Petition No. 1220 Interrogatories Set Two April 26, 2016 Ir LLC (WS) Responses I

- Windham Solar LLC (WS) Responses May 8, 2016 General Questions
- 39. Referencing the response to question 22 of the first set of interrogatories, provide the status of the wildlife biologist review of the site with respect to federally-listed and State-listed species, including but not limited to the northern long-eared bat. In general, does the site have large trees in the 12-inch diameter or greater range in the proposed tree clearing area? WS is currently reviewing proposals and selecting a biologist for the project. A majority of the site is pine, ranging from 8"-15" diameter trees, however a specific tree survey has not been performed. WS is aware of the northern long eared bat requirements relating to tree clearing and the pup season. WS's biologist will review the sites for potential habitat for all species and outline requirements for the construction of the project which adheres to state and federal requirements.

VOLUNTOWN RD. SOLAR

OVERALL SITE PLAN

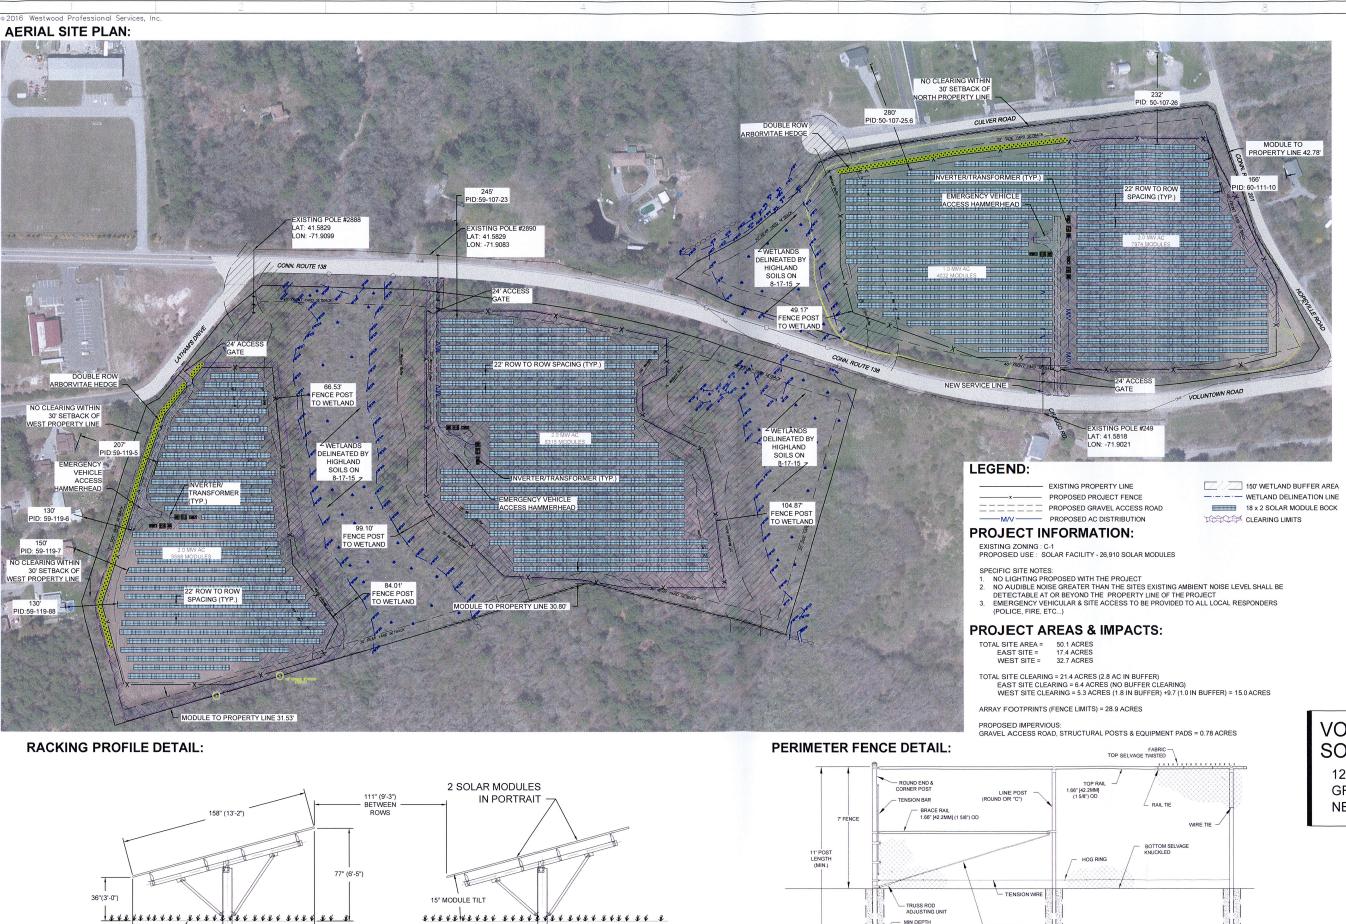
- 40. Has Windham Solar LLC (WS) considered the municipal comments filed by Mario J. Tristany, Jr., Griswold Town Planner dated April 20, 2016 including but limited to the request to shift the western-most array to the east and also maintain and supplement the landscape screening to the north of the northern-most arrays? The municipal comments may be viewed at: http://www.ct.gov/csc/cwp/view.asp?a=2397&q=578334
 A revised site plan has been attached (Exhibit A) addressing the town of Griswold's planning concerns.

- 41. Has WS also considered the Griswold Inland Wetlands & Watercourses Conservation Commission & Acquifer Protection Agency comments dated April 25, 2016? Would WS be amenable to prohibiting the use of herbicides and similar chemicals in the upland review areas? Please identify any chemicals or cleaning agents that would be used to periodically clean solar panels. These municipal agency comments may also be viewed from the Council's website at: http://www.ct.gov/csc/cwp/view.asp?a=2397&q=578334
 A revised site plan has been attached (Exhibit A) addressing the town of Griswold's Inland Wetlands and Watercourse Conservations concerns.

- a) Provide the most up to date Overall Site Plan drawing (i.e. Sheet 4 of 12 from the Petition) taking into account any revisions that have been made to the number and locations of solar panels proposed, megawatts proposed at this time, access proposed, supplemental landscaping plantings proposed, etc. Explain in writing the reasons for the changes such as municipal comments and resident concerns, environmental issues at the site, etc. Indicate how many feet the western-most array would be shifted to the east, if applicable. If the northern-most arrays are rearranged for a greater buffer to Culver Road and to allow landscaping, indicate this also.

c) Would the acreages of tree clearing remain approximately the same as in the response to question 23, set one with 20.8 AC total including 1.8 AC with wetland buffers, or, for example, would the wetland buffer area clearing increase with a shift to east (of the western-most array)? Provide the revised tree clearing areas estimate, if applicable. If the total tree clearing area changed from 20.8 AC, recalculate the carbon debt payback based on the new acreage of tree clearing versus proposed energy generated (similar to the response to question 24 of the first set of interrogatories).

Exhibit A Represents the latest site plan. Two major areas were addressed with this site plan revision:

The west array by Latham Drive was pushed 80' east from the project property line. This shift was to allow for 30 feet of un-cleared buffer area to remain and 50 feet of clear space from the existing tree line to minimize late day module shading. Within that clear area, a double row arborvitae hedge is illustrated for additional year round screening. WS will maintain the arborvitae hedge to a maximum height of 20 feet, to ensure that the proposed landscape screening doesn't shade and limit production of the solar facility.

The east array by Culver Road was pushed south, and modules were stretched into the current agriculturally farmed wetland buffer area. A double row arborvitae hedge is proposed along the north fence line to improve screening where the existing vegetation is less dense.

All revised module counts, and impact areas are represented on the revised site plan.

Tree clearing acreages have been revised and are illustrated on the site plan. A summary of areas is below:

TOTAL SITE AREA =50.1 AC EAST SITE = 17.4 AC WEST SITE = 32.7 AC

TOTAL SITE CLEARING = 21.4 AC (2.8 AC IN BUFFER)
EAST SITE CLEARING = 6.4 AC (NO BUFFER CLEARING)
WEST SITE CLEARING = 5.3 AC (1.8 IN BUFFER) +9.7 (1.0 IN BUFFER) = 15.0 AC
